**Section 75W Modification  
Project Approval  
(MP07\_0158) Minor  
Design Alteration to  
Abercrombie Student  
Accommodation Building**

Abercrombie Precinct

Redevelopment, University of  
Sydney

Prepared By McKenzie Group Consulting  
Planning for John Holland.

Figure 4: Proposed Roof Plan (Nettleton Tribe Partnership, 2014)

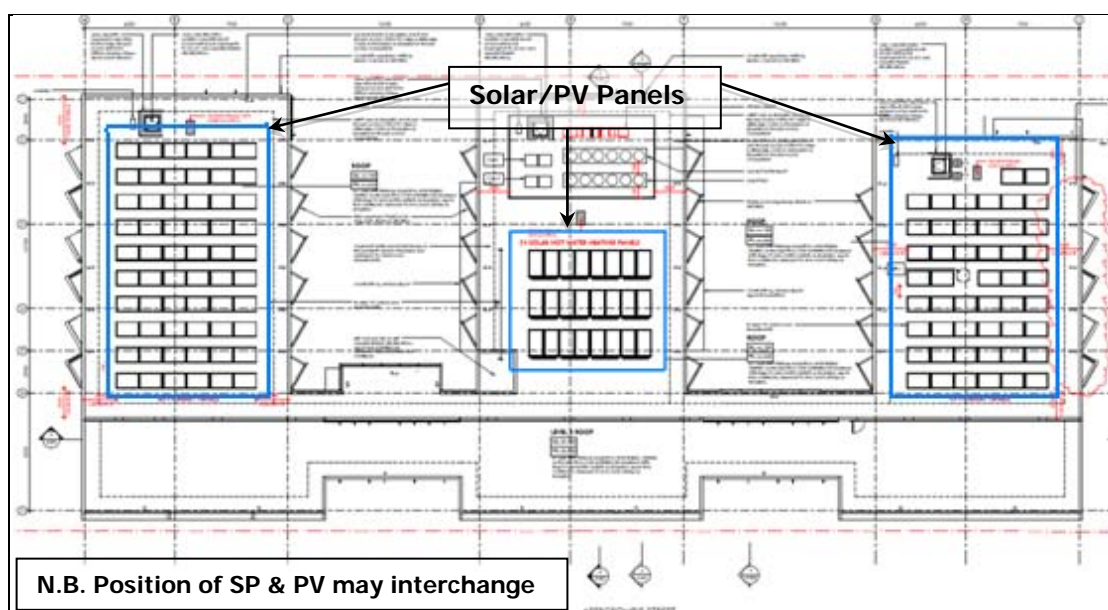
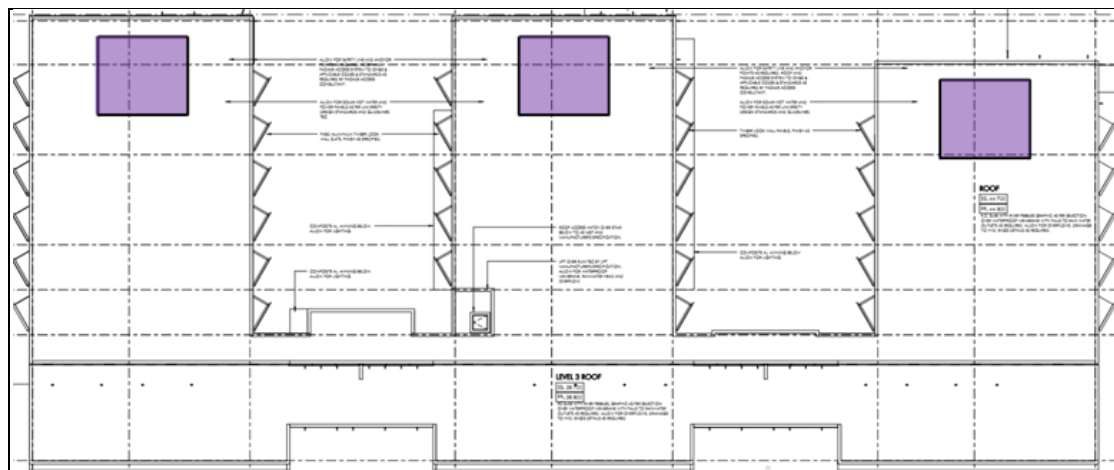
The proposed roof plan has been provided in **Appendix 3**. The proposed modification requires the inclusion of the ASA roof Plan (NTA-ASA-ARC-PDF-117-K) under Condition A2, with the addition of hot water solar panels (SP) and photovoltaic (PV) cells.

The above modification to the roof plan is minor and impacts resulting from the solar panels are considered to be negligible. The solar panels will not be viewable from any public spaces and will not result in an increased building height, overshadowing or acoustic impacts. Furthermore nuisance reflectivity is to be mitigated via angling of the panels to the north away from public spaces.

**Figure 5.** Extract from the approved Roof Plan (NTA-ASA-PDF-117-D) showing the three plant rooms (purple) as proposed in MOD 3.

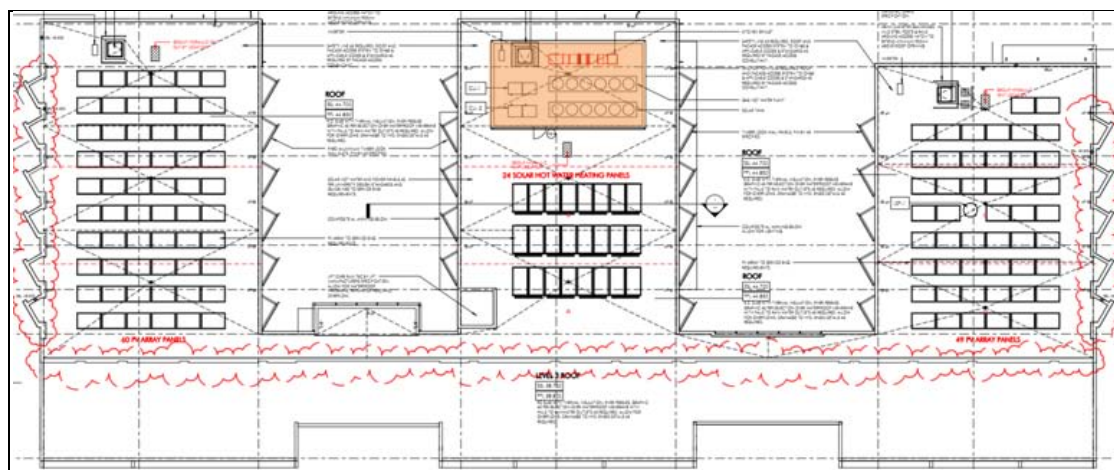
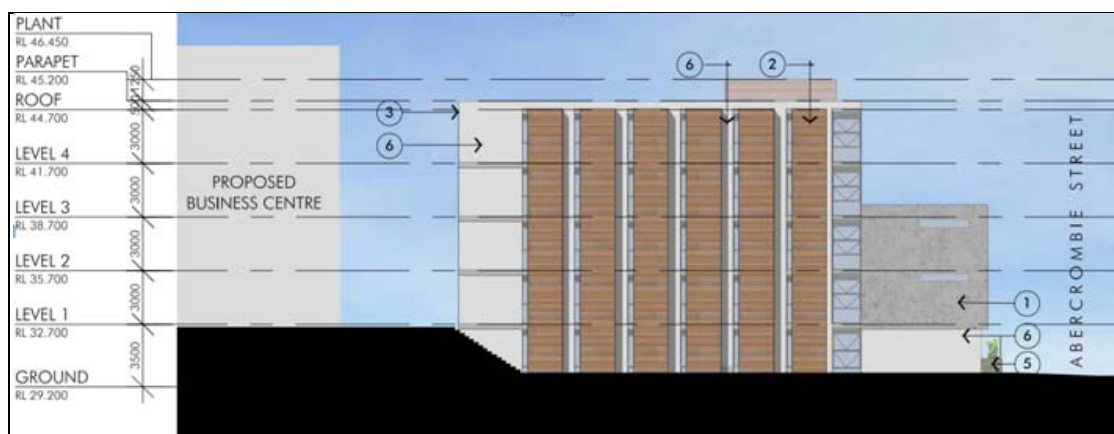
The architect originally assumed there was need for three plant rooms as shown in Figure 5. However, design rationalisation since John Holland was appointed head contractor for the Abercrombie Student Accommodation has reduced roof top plant rooms to one, located in the middle wing as per Figure 6. This result also has the added benefit of creating more space for the SP and PV cells.

**Figure 6.** Extract from the proposed Roof Plan (NTA-ASA-PDF-117-K) for approval, showing the location of the consolidated plant room (orange).

**Figure 8.** Extract from the proposed Elevations (4001\_DA06-G) showing western side of the building.

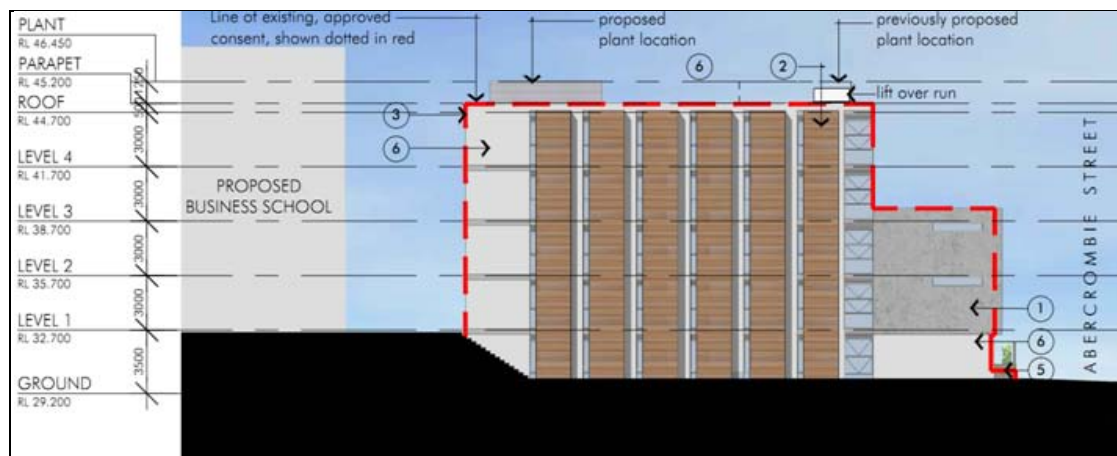
A comparison of the western elevation (Figures 7 & 8) indicates that the top of the plant room, and also the highest point, on the ASA building, remains unchanged at RL 46.50. The location of the proposed consolidated plant room, as per Appendix 7 NTA-ASA-PDF-117-K, is at northern end of the building, facing towards the New Business School, thereby maximising the distance from Abercrombie Street residences.

**Figure 9.** The design as it appears in 4001\_DA011-F: Façade Details, which was approved as part of MOD 3 on 31 March 2014.

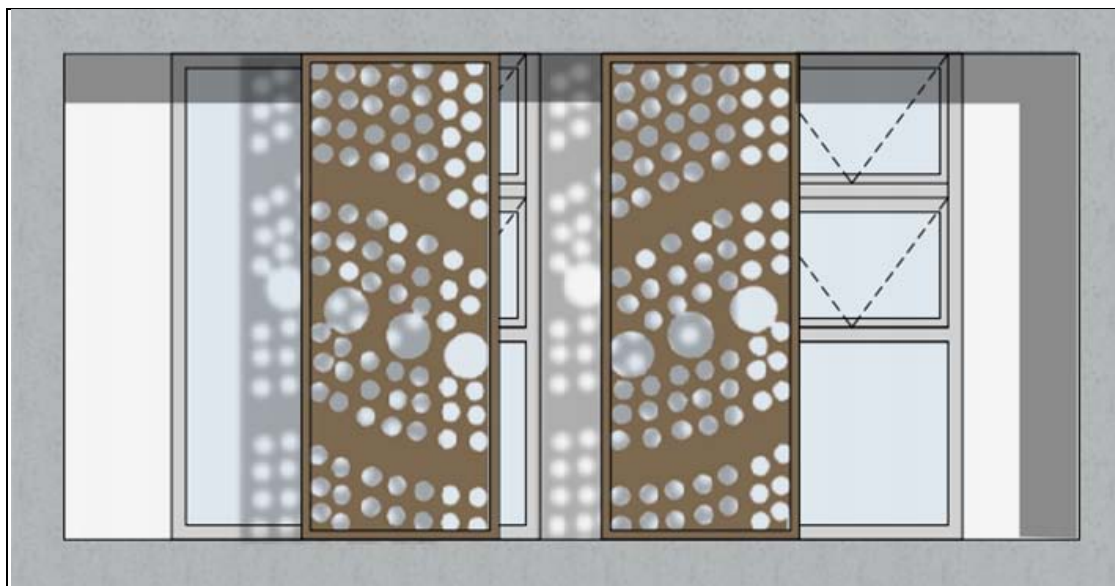
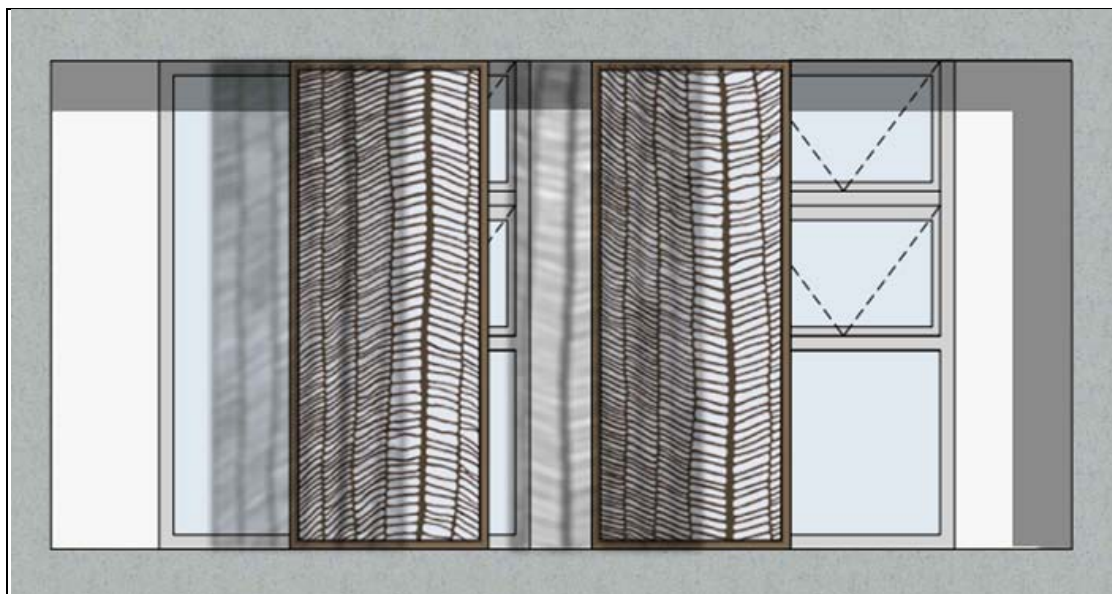
The proposed modification is limited to the alteration of the pattern on the copper coloured screens planned for the southern façade of the ASA building. The initial design is shown in Figure 9, while the new design is shown in Figure 10. The approved material, colour and finish will remain the same.

**Figure 10.** The screen design as proposed by this modification. Extracted from 4001\_DA011-G: Façade Details.
